PROJECT: Washington Street Improvement Project, Main Street to  
Vista Drive  
City Project Number ST2015-08

**ADDENDUM NO. 2**  
**To the Contract Provisions for**  
**CITY OF FERNDAL, WASHINGTON**

**Washington Street Improvement Project**  
**Main Street to Vista Drive**  
**City Project Number ST2015-08**

**ADDENDUM NO. 2**

DATE  
3/2/2018  
SHEET  
11  
of 38

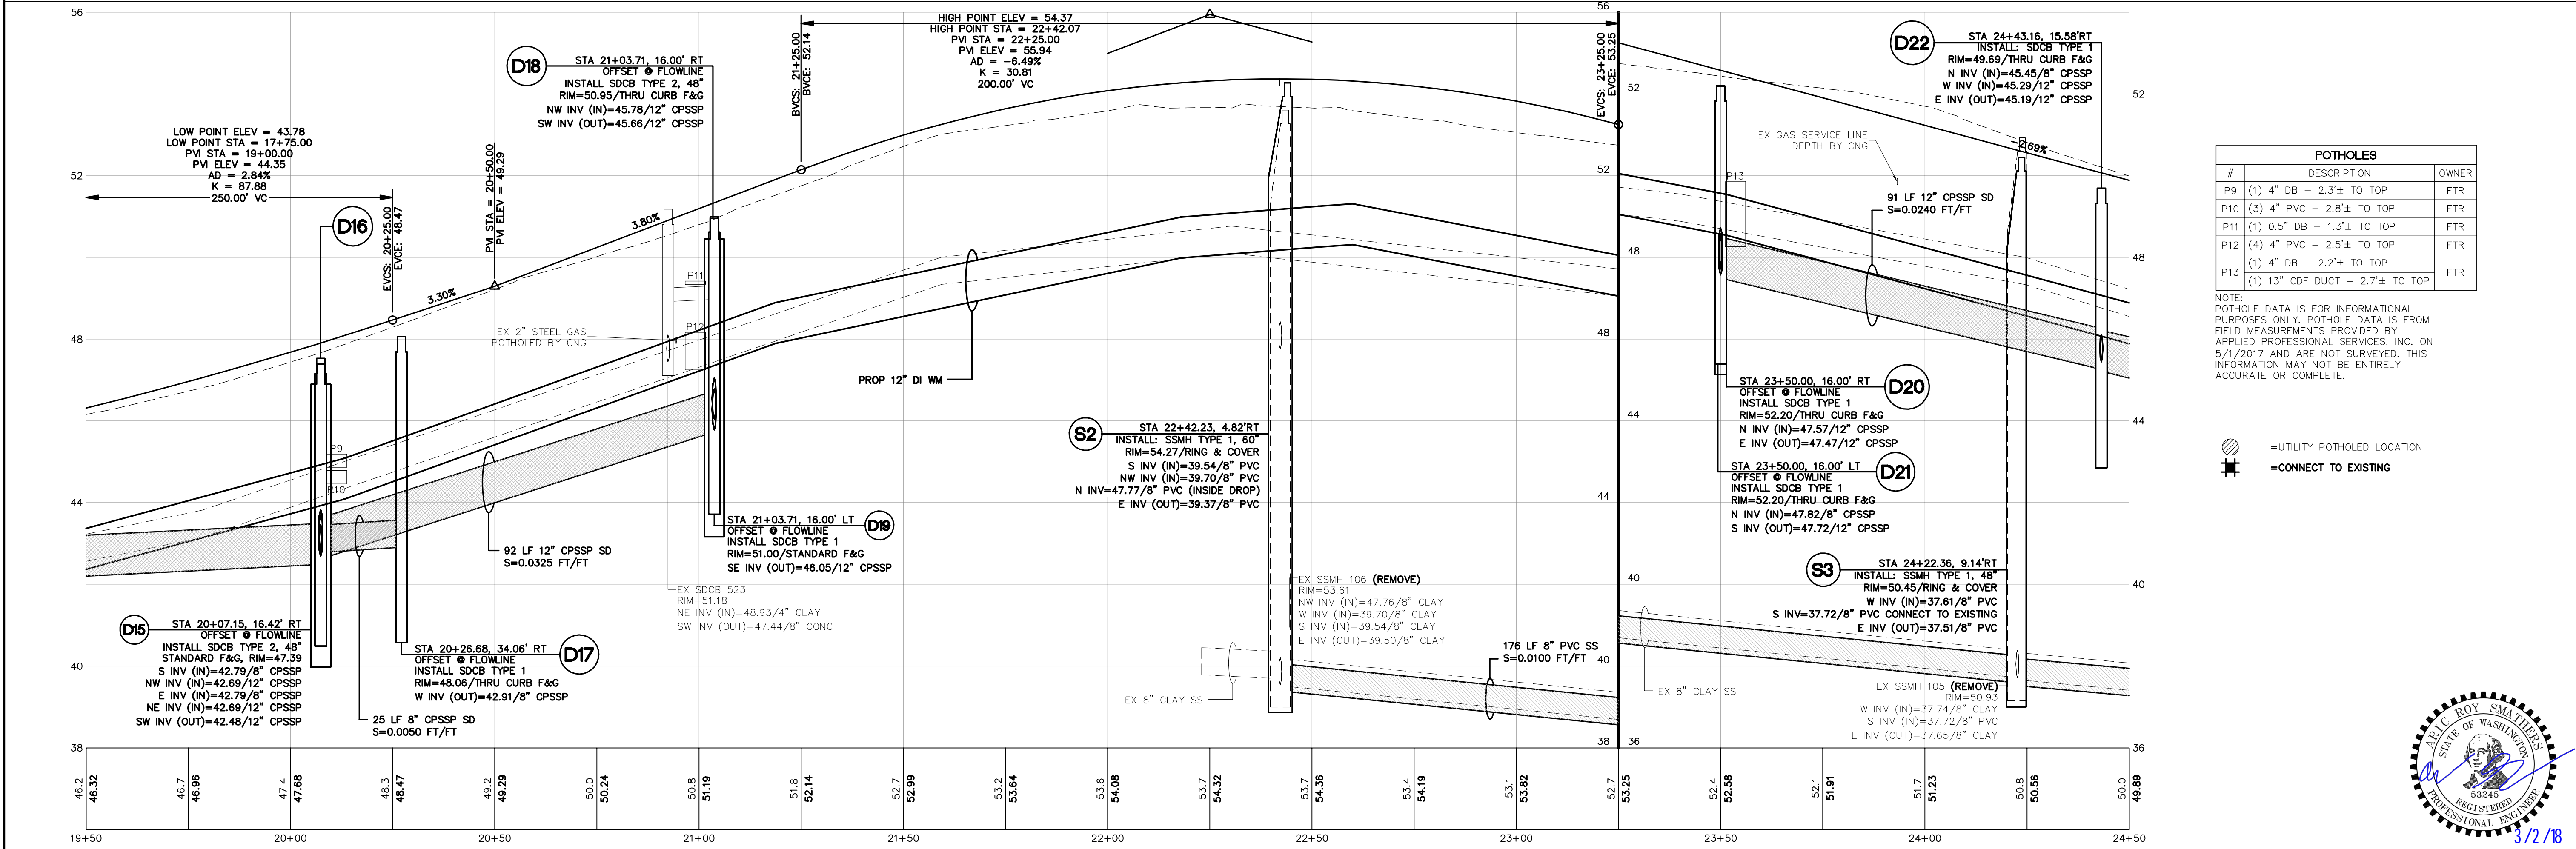
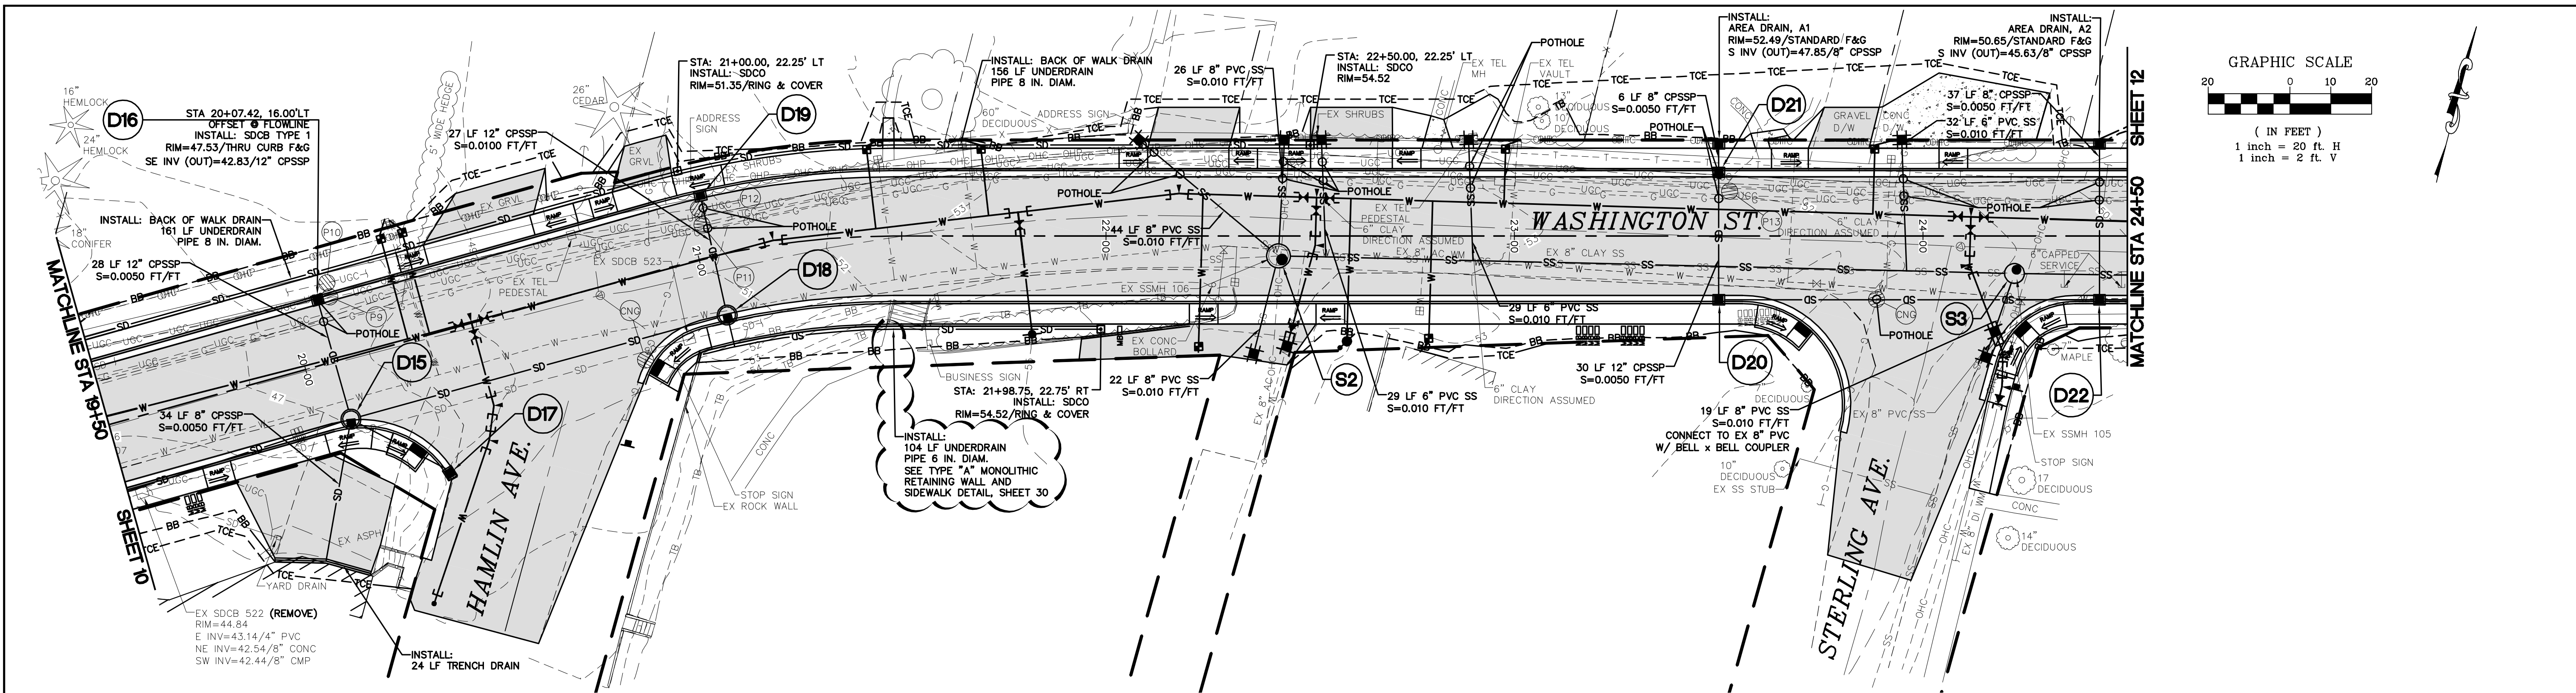
**Plan Sheet 11**

A label was added to the 104 LF of “Underdrain Pipe 6 In. Diam.”.

DWG 16026 CHAN	DATE 3/2/2018
JOB# 16026	SHEET 31 of 38
SCALE H: 1"=20' V: N/A

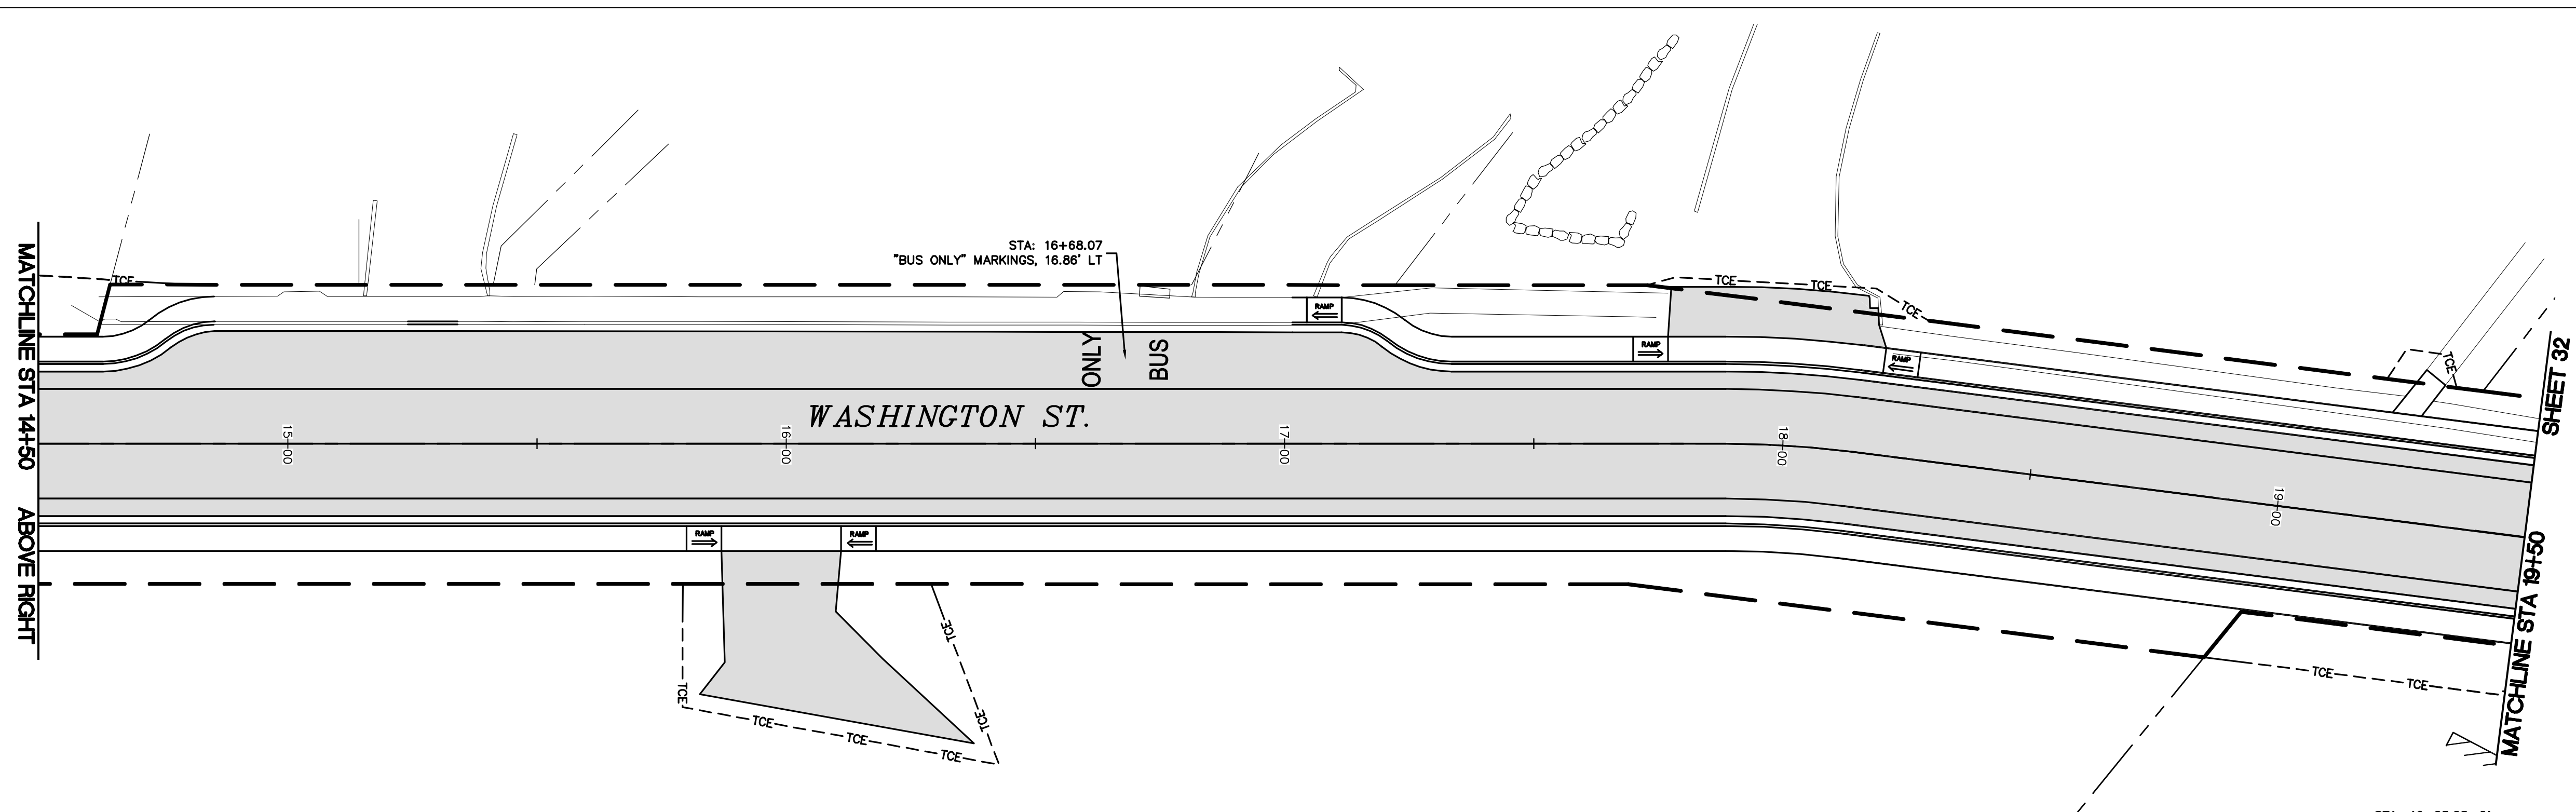
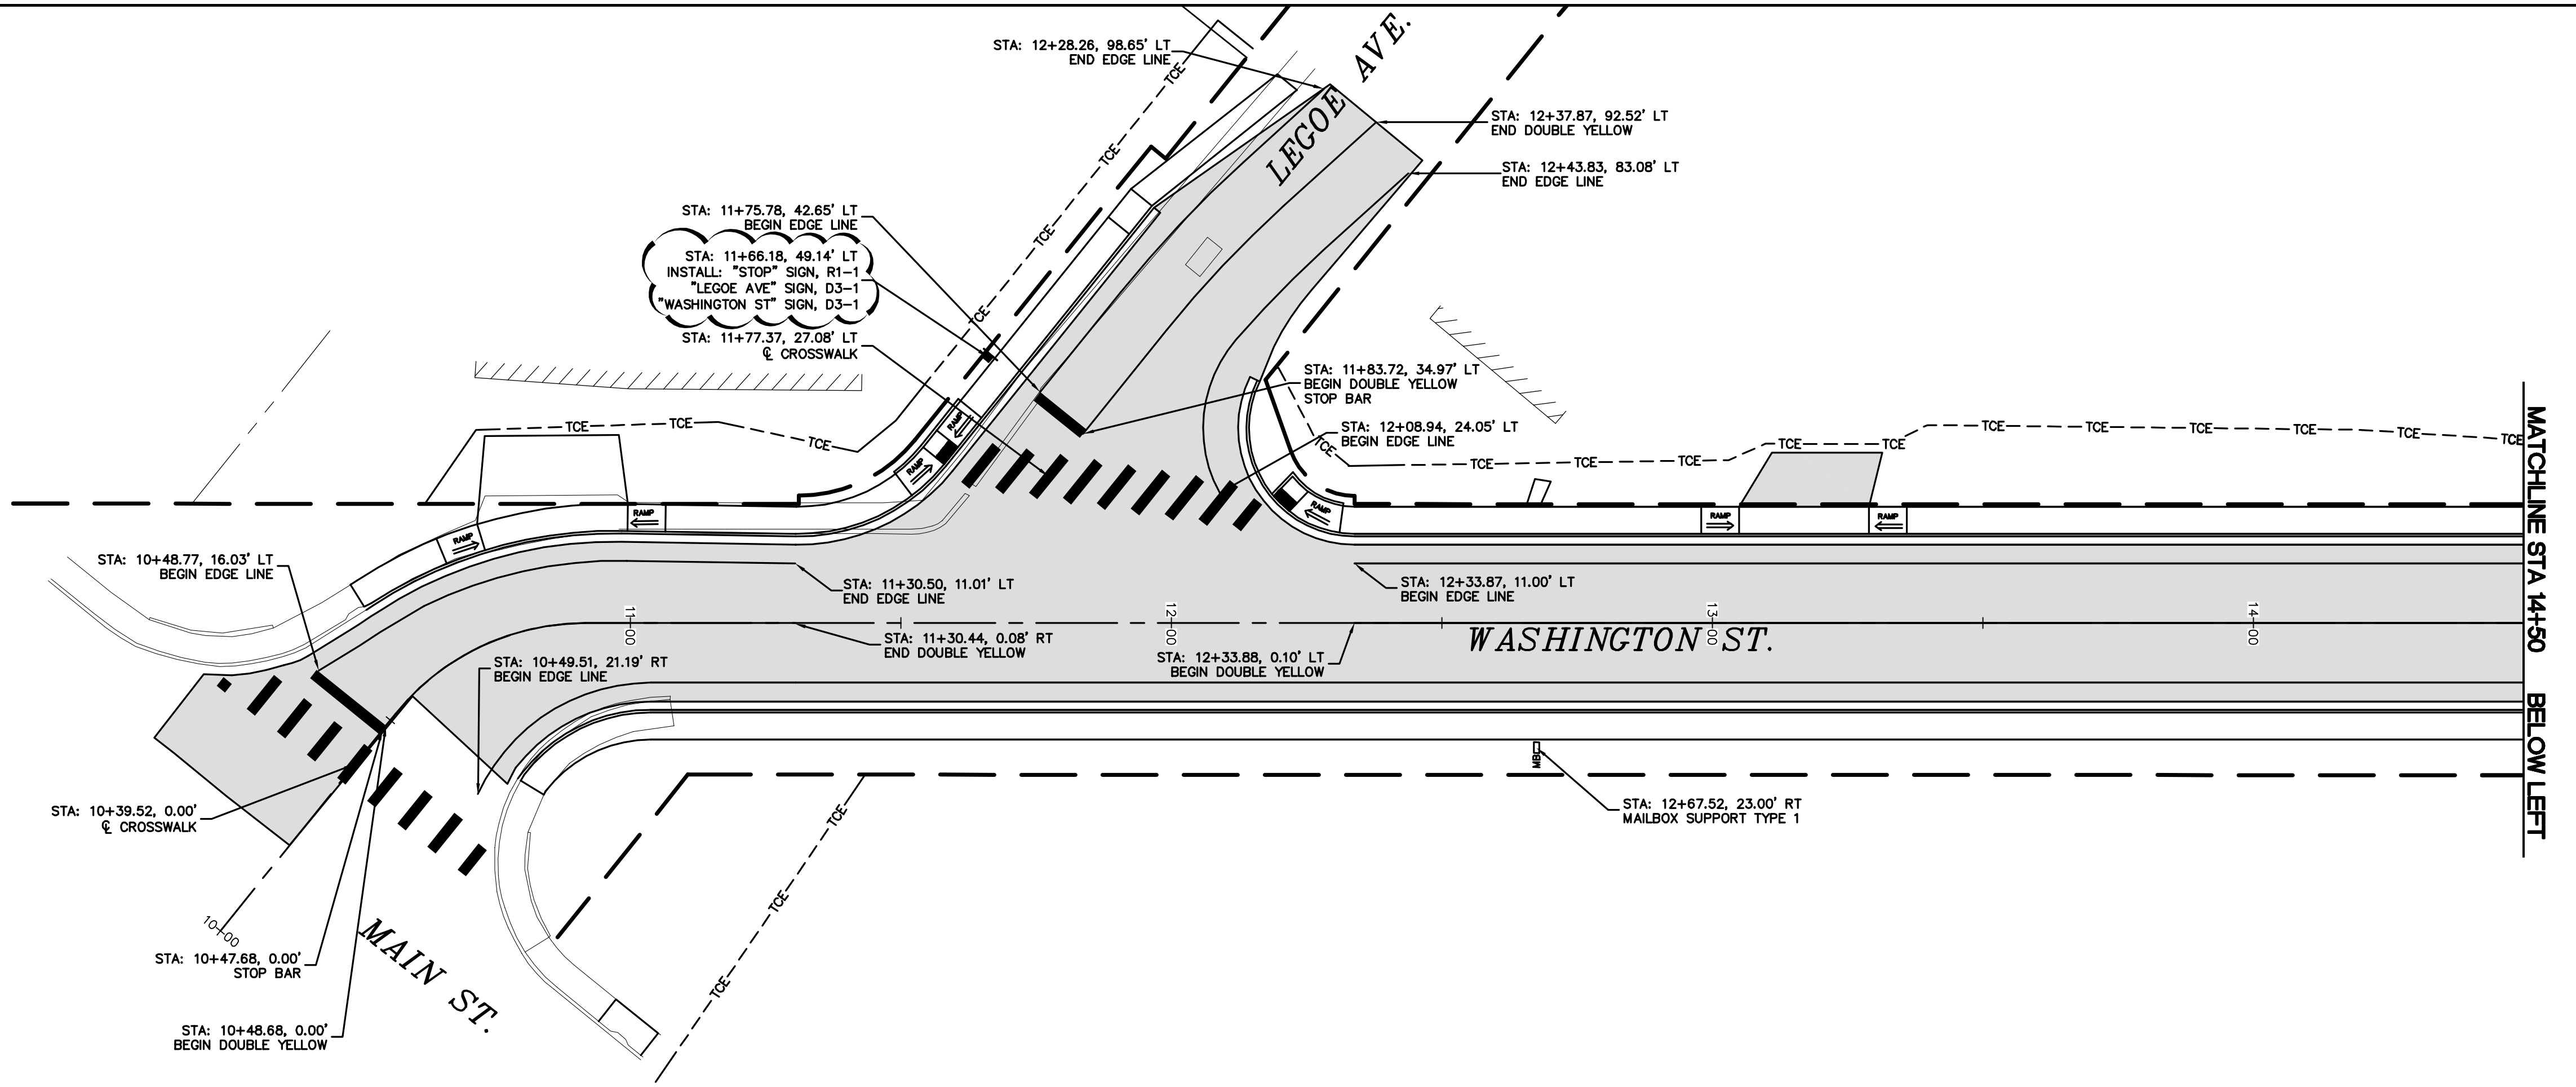
**Plan Sheet 31**

The installation of the street signs at the intersection of Legoe Avenue and Washington Street are now labeled.
